# Chambers Reservoir Slope Failure on the South-West reservoir slope

Field Inspection 4-25-17

# Overview

# Main Scarp (stage 1)

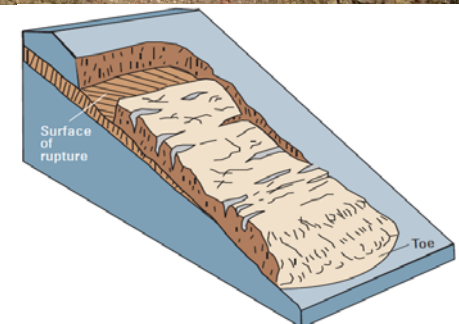
- Planar surface
- Sand & fine gravel
- Dry

## Other Un-stabilities

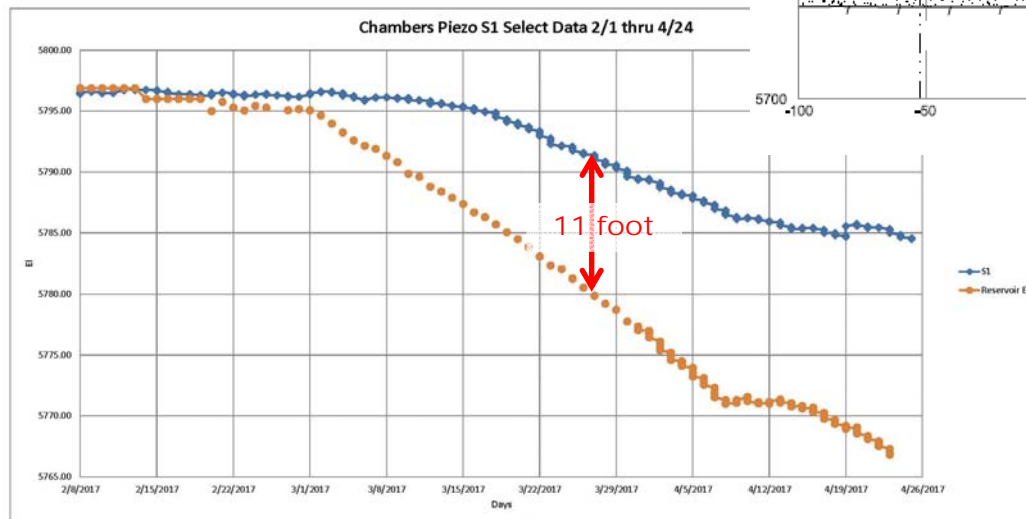
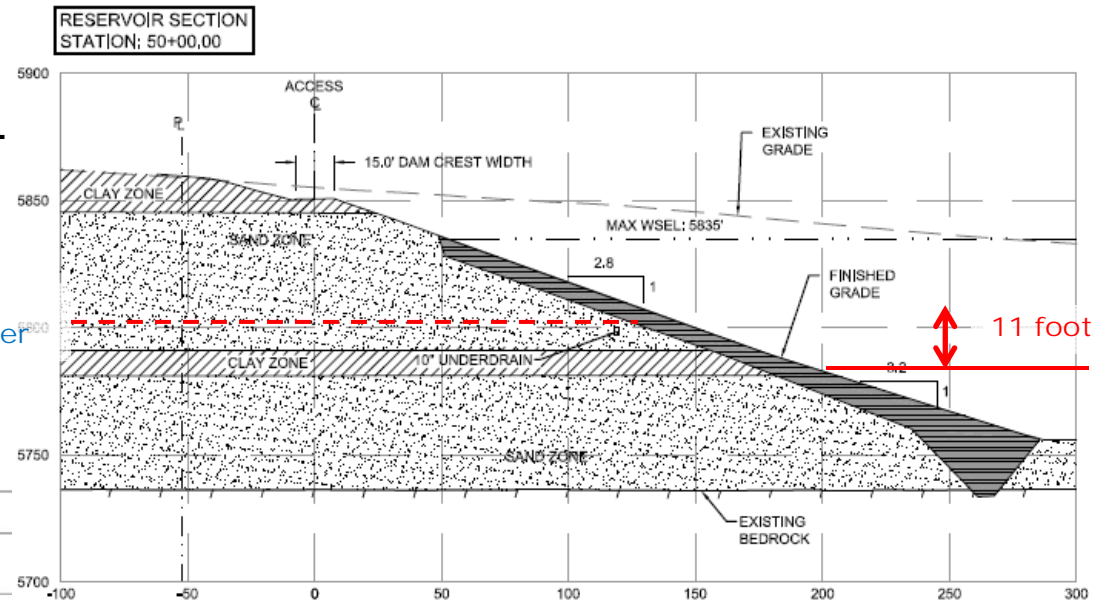
- Tension crack/slope movement (~145' long)
- 200' north of larger instability
- Similar height to other head scarp
- 6-inches vertical movement

- Tension crack/slope movement
- South edge of larger instability
- 6 to 10-inches vertical movement

# 2010 Design

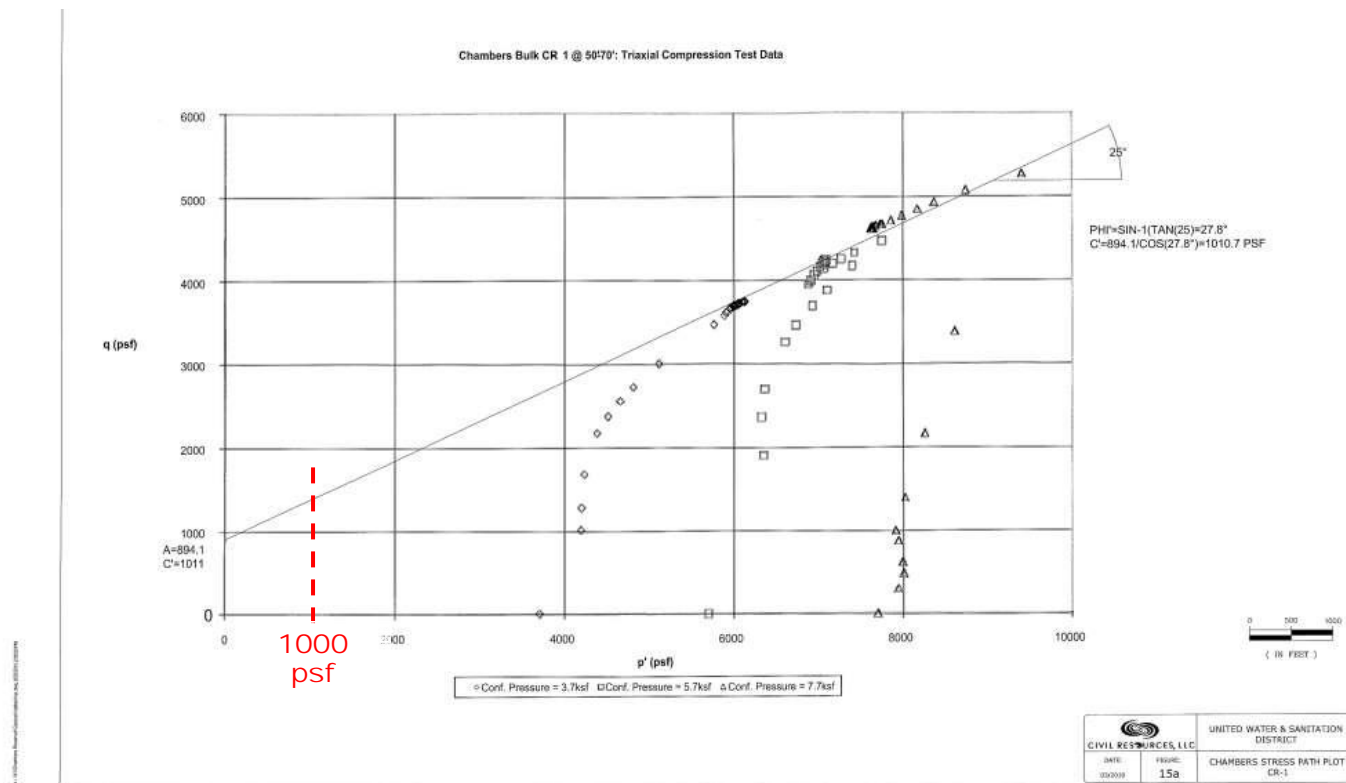
- Shear Strength Parameters
  - Triaxial testing performed at stresses exceeding the stress of the CCL (3,700psf to 7,700psf)
  - Triaxial test results may over-estimate strength of CCL (both drained and undrained).
